SUMMARY OF REV#1

NEW FOOD DISTRIBUTION
HEALTHY SCHOOL
FOOD COLLABORATIVE

SHEET TITLE:
POWER PLAN

E101

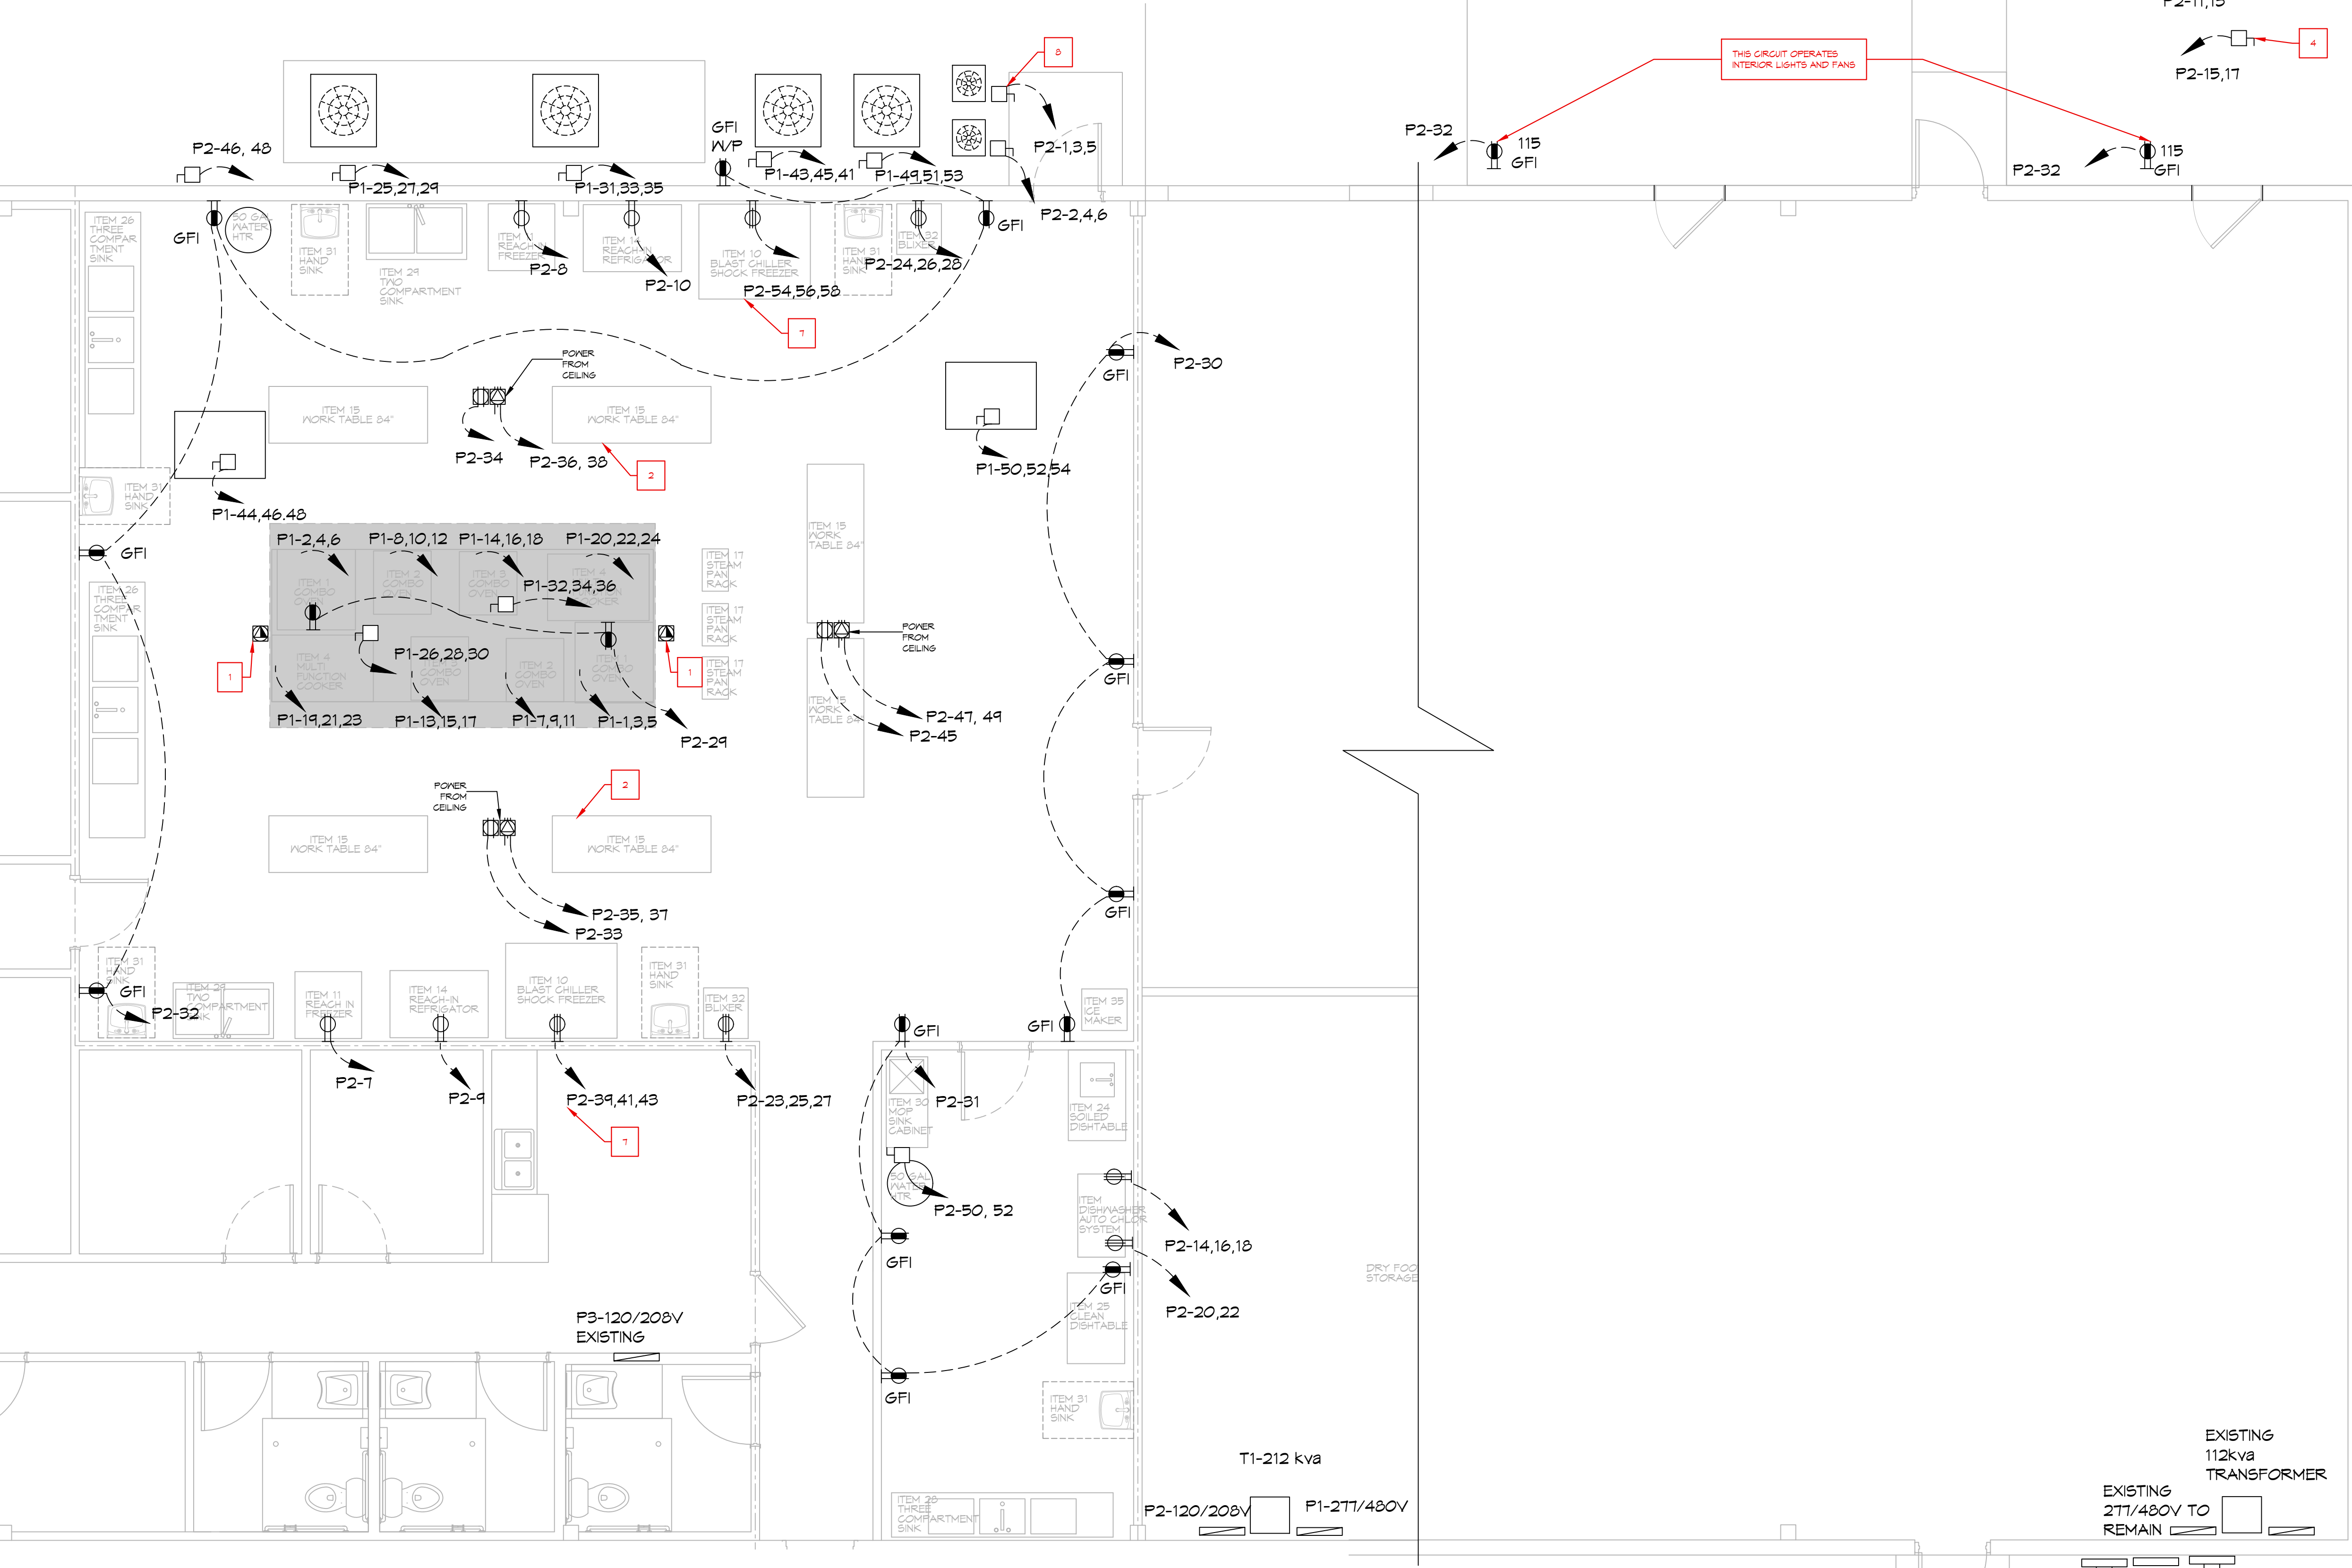
- REMOVAL OF POWER POLES NEXT TO HOOD, UNDERGROUND CONDUITS HAVE BEEN PROVIDED.
- REVISED POWER DROPS FROM 2 DROPS TO 1 DROP, ITEM 15 WORK TABLES CENTER POWER DROP BETWEEN TABLES.
- RELOCATED 3 POLE RECEPTACLE FROM WALK IN COOLER TO WALK IN FREEZER AND CHANGED FROM 3 POLE TO 2 POLE DISCONNECT.
- CHANGED WALK IN FREEZER 3 POLE RECEPTACLE TO 2 POLE DISCONNECT.
- ADDED 2 EA 3 POLE DISCONNECT FOR WALK IN COOLER REMOTE CONDENSERS.
- ADDED 2 EA 3 POLE DISCONNECT FOR WALK IN FREEZER REMOTE CONDENSERS.
- MOVED CKTS ON PANEL.
- ADDED 2 EA 3 POLE DISCONNECTS FOR BLAST CHILLER EQUIPMENT.
- ADDED NEW SUB-PANEL P4.

NOTE: THESE ARE NECESSARY REVISIONS DUE TO ACTUAL EQUIPMENT INSTALLED ON SITE THAT WERE NOT SPECIFIED IN THE ORIGINAL DOCUMENTS PROVIDED.
